# SERVICE BULLETIN SB1355

ADDRESSEES	: Owners and operators of coaches listed under "Application"
VEHICLE MODEL	: CX45
SYSTEM/SUBSYSTEM	: 01.09 Complete vehicle - Automatic fire suppression system
BULLETIN TYPE	: Field Change Program
DATE	: August 25th, 2016
SUBJECT	: To change routing of extinguishing agent hose and check routing of linear detection wire
TERMS & CONDITIONS	: Refer to the warranty section further in this Bulletin

## **STEP 2 IN DETAIL**: To change routing of extinguishing agent hose

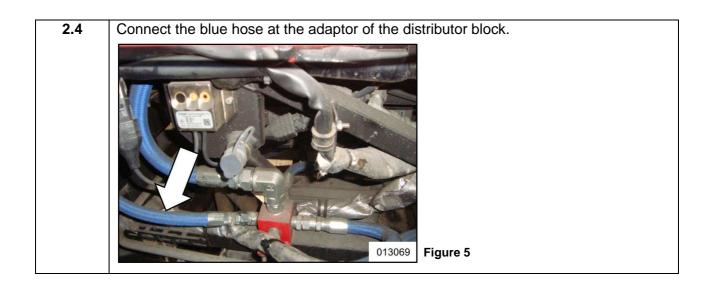
On the above-mentioned vehicles, one of the extinguishing agent hoses of the automatic fire suppression system is routed in a way that it can be damaged during the installation of the front floor trap above the engine. Therefore this extinguishing agent hose must be re-routed as described in this Service Bulletin. Also the routing of the linear detection line has to be checked and, if necessary, re-routed to avoid possible damage during the installation of the floor trap.

## STEP 3 IN DETAIL: To check routing of linear detection wire

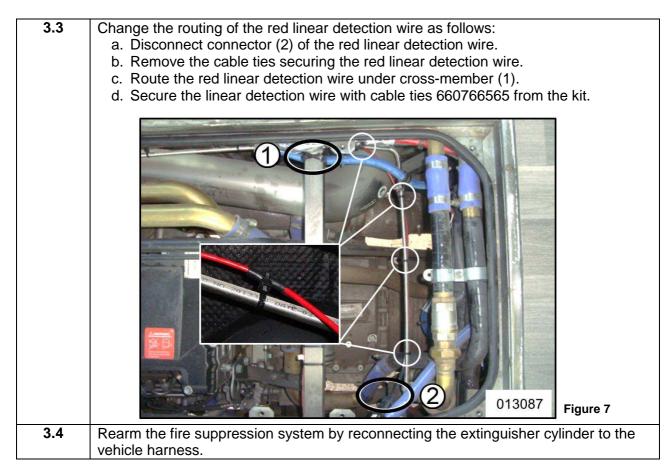
Step	Action
3.1	<ul> <li>Is the red linear detection wire routed under the cross-member as indicated in the figure?</li> <li>If so, continue with step 4 of the procedure.</li> <li>If not, go to step 3.2.</li> </ul>
	Figure 6
3.2	Disarm the fire suppression system by disconnecting the extinguisher cylinder from the vehicle harness.
